Access Compliance Report Public Rights-of-Way (Curb Ramps)

Main Street: VERA_ST Cross Street: WARREN_AVE Location: E

ADA ID: RPAT211027113849 Ramp Type: Type 6 - Directional 1 Initial Pass/Fail: Fail Overall Compliance: No Severity Score: 19

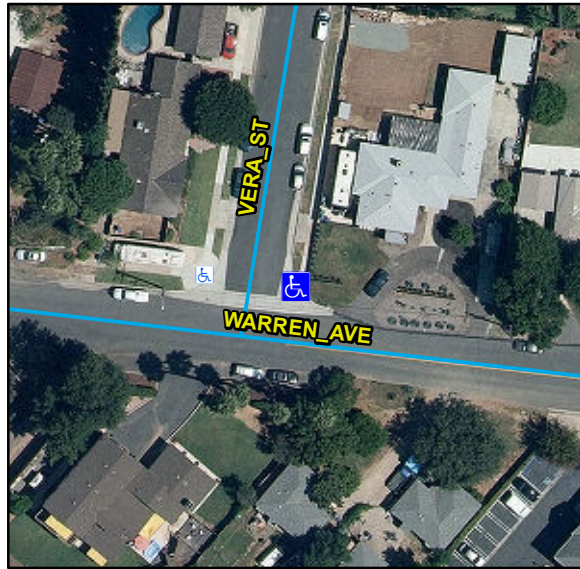
Compliance	Description	Data	Compliance	Description	Data
N/A	Ramp Length (in)	130	N/A	Flare Type LT	
No	Ramp Width (in)	45			N/A
No	Ramp Run Slope (%)	8.4	N/A	Flare Slope LT (%)	N/A
Yes	Ramp Cross Slope (%)	0.9	N/A	Flare Traversable LT	N/A
N/A	Grade Break	N/A	N/A	Flare Type RT	
N/A	Grade Break Slope (%)	N/A			N/A
N/A	Grade Break Cross Slope (%)	N/A	N/A	Flare Slope RT (%)	N/A
	Addl Para Ramp Left?	No	N/A	Flare Traversable RT	N/A
	Addl Para Ramp Right?	No	N/A	DWS Provided	N/A
N/A	Landing Present	N/A	N/A	DWS Contrast	N/A
N/A	Landing Length (in)	N/A	N/A	DWS Length (in)	N/A
N/A	Landing Width (in)	N/A	N/A	DWS Full Width	N/A
N/A	Landing Run Slope (%)	N/A		DWS Offset Type	N/A
N/A	Landing Cross Slope (%)	N/A	N/A	DWS Left Offset (in)	N/A
N/A	Landing Movement Obstructed?	N/A	N/A	DWS Right Offset (in)	N/A
	Landing Movement Type	N/A			
N/A	Landing Shared	N/A			
N/A	Marked Crosswalk 1	No	N/A	Clear Space	N/A
	Crossing 1 Direction	NW	N/A	Clear Space To Crosswalk (in)	N/A

Marked Crosswalk 1 Width (in)	N/A			
N/A	Ramp Inside Crosswalk 1	N/A			
	Crossing 1 Slope (%)	1.2			
	Crossing 1 Cross Slope (%)	3.8			
N/A	Gutter Ponding	N/A	N/A	Curb Slope	4.7
Yes	Gutter Lip Height (in)	0		Road Run Slope (%)	N/A
N/A	Gutter Run Slope (%)	N/A		Road Cross Slope (%)	N/A
N/A	Gutter Cross Slope (%)	N/A		Parallel Ramp Side	N/A
Yes	Overall Surface Condition	Acceptable	Yes	Perp Joint Present	Yes
	Cross Gutter Present?	Yes		Spandrel Present?	Yes
	Replace Cross Gutter?	No		Replace Spandrel?	No

Remove & Replace Entire Ramp.

R304.5.1, R304.2.2, STD 1115
